Thanks for the review of our garage plans and your suggestions. We've provided more information below.

1852 Summit Ave Garage update plans and product list

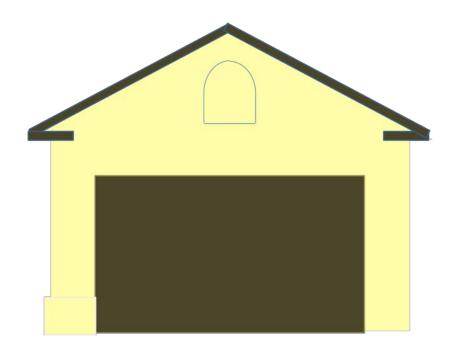
- 1. After reviewing your proposal with Building Inspection and Zoning, the one point of feedback from them was that building code will require additional wind bracing for the pedestrian door on the front of the garage, which might be challenging. I see that you're trying to have a pedestrian door both inside the existing gate and outside the gate. I'm wondering if it would be more practical to only have the pedestrian door on the side of the new garage and modify the fence to accommodate egress? Your call on that front.

1. We have removed the pedestrian door from the garage front and will have a wider garage door of 12 feet. Egress will be provided through the one door on the side and the garage door. This addresses concern about the wind brace. The large tree

precludes changes in the fencing.

a. We will replicate the niche in on the front of the existing garage (photo below)

Here is a crude sketch of the new front façade with the pedestrian access door removed and the door expanded to 12 feet width, wind bracing should now be easy:

Door Design 12 (p.9)

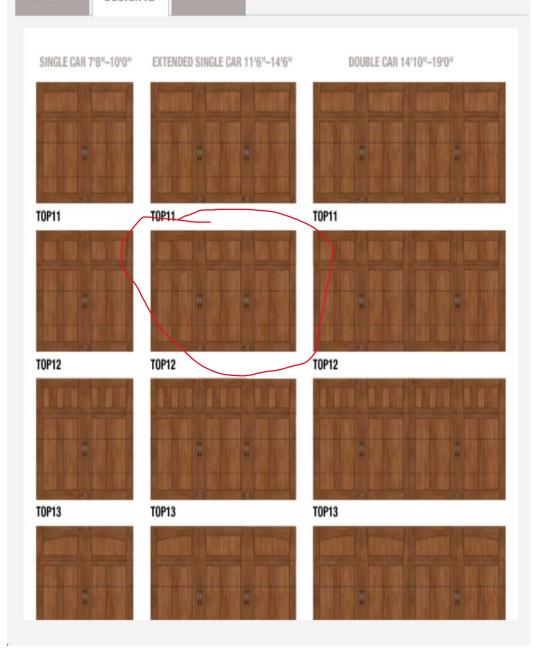
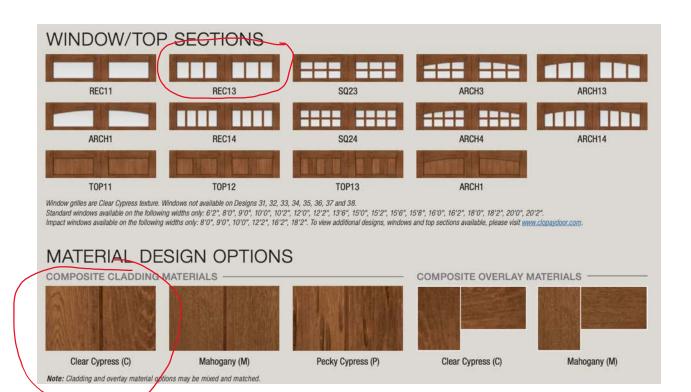
- 2. Could you get me updated drawings by June 22 for any changes you're going to make? I also need the product sheets identifying which garage and pedestrian doors you're proposing (if there are multiple options on the product sheet, please indicate which options you're proposing), You included a product list, but the Landmarks Commission will need to see what the products look like to be able to determine if they meet the requirements of the preservation ordinance.

<u>Cloplay Canyon Ridge Carriage House Brochure</u> – 5 layer

Clear Cypress composite and overlay (p. 8)

Window/top section – rec 13

Walnut finish

Extended 1 car size – 12 feet
